Technical Service Bulletin: TSB140137

ISX 12/15 CM2250/CM2350 Variable Geometry Turbocharger (VGT) Turbocharger Bearing Housing Coolant Leak Test - Service Tool Leaks

Figure 1

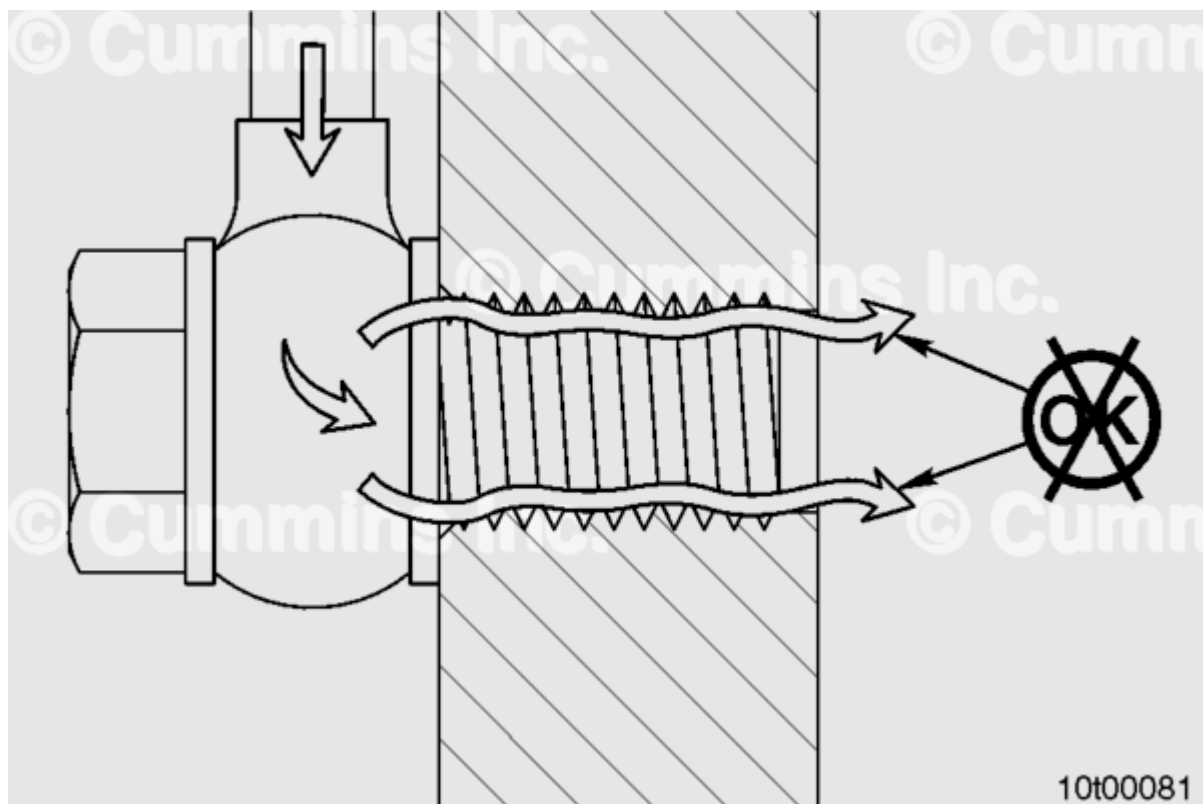
Turbochargers are being returned due to failing the bearing housing leak test when using Service Tool Kit, Part Number 2892101, as described in Procedure 010-033 (Turbocharger) in the service manual. It was found that the actual leak was caused by the service tool. The block off fittings do **not** provide enough shoulder for the inner seal of the banjo washer to seal properly, allowing air to leak down past the bolt and mating component threads. See Figure 1.
